Development Application Assessment

Application Reference	Road Reserve	Number of Signs
PA24-5035	Bishop Road	3
PA24-5036	Taylor Road and Adams Street	7
PA24-5037	Richardson Street	1
PA24-5038	Adonis Street	2
PA24-5041	Kargotich Road	3

Site Plans

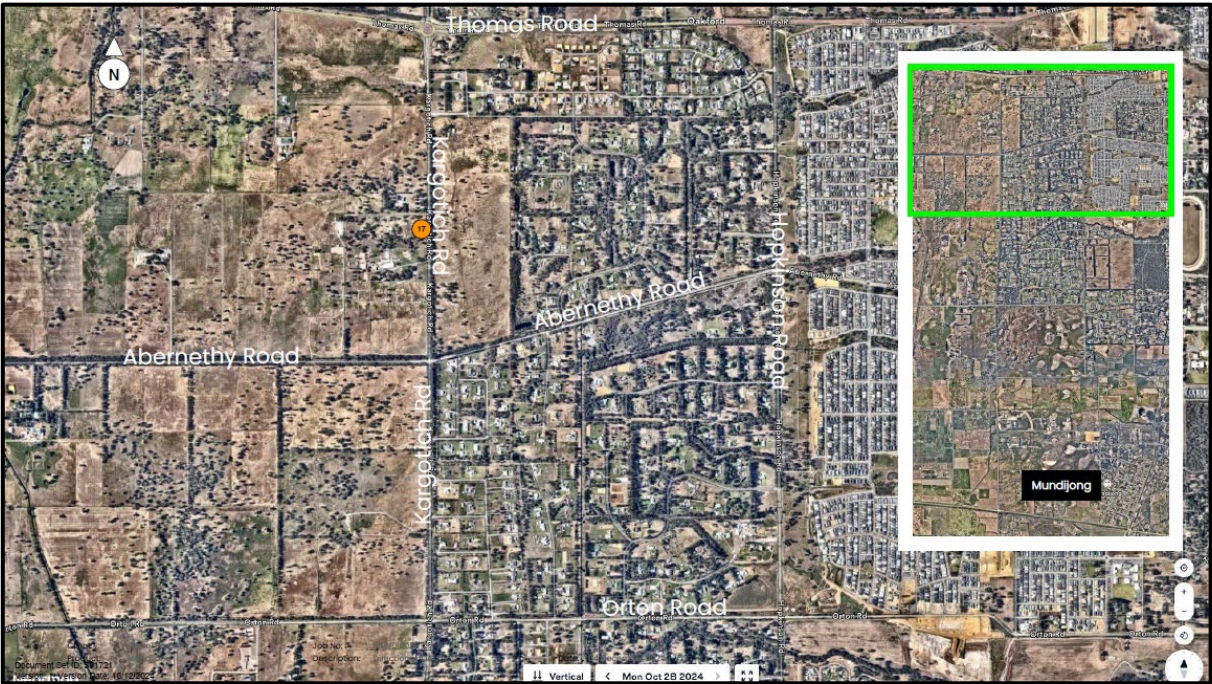
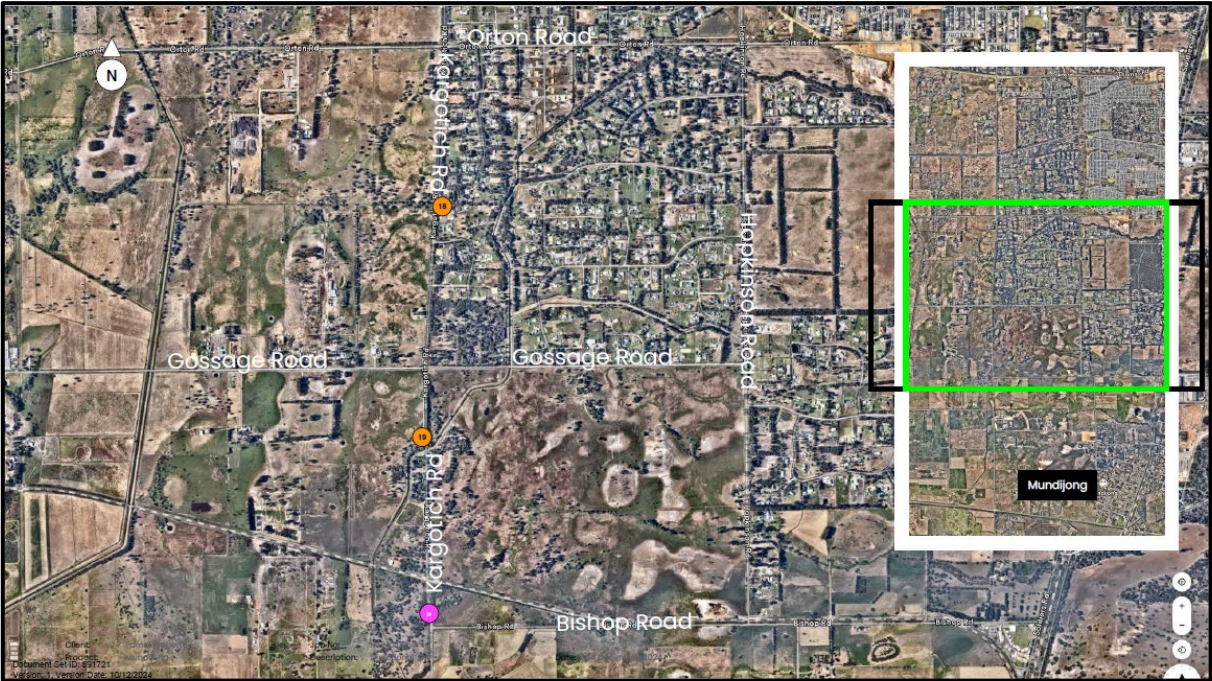
Provisions				Proposed	Comment																			
Commercial signage should only display information of available commercial and/or retail services located within the town centre environment where the commercial sign is proposed.				The signage displays advertisement for new housing opportunities at the Mundi Estate, which assists in advocacy for the Shire. The signage is located at important entry roads including Kargotich Road and Bishop Road.	Compliant																			
In assessing consideration of acceptable positioning of commercial signage, the following table will be given regard in respect of setbacks from the edge of the road carriageway curb:				The pylon sign are considered non-frangible since they are not considered brittle, fragile or easily broken. Officer has measured the separation distance from each sign to the road carriageway curb and found only Sign 19 is non-compliant. Table and	Non-compliant. See Report

<p>Commercial signs will not be permitted if they impede pedestrian, bicycle or vehicular movement.</p>	<p>Signs is located outside of road carriageways and does not obstruct the movement of vehicles.</p>	<p>Compliant</p>
<p>When assessing a permit application for commercial signage on a local government road reserve consideration will be given to the</p>	<p>- The pylon sign is relatively small in scale: 2.2m height x 1m width;</p>	<p>Non-compliant. See Report</p>
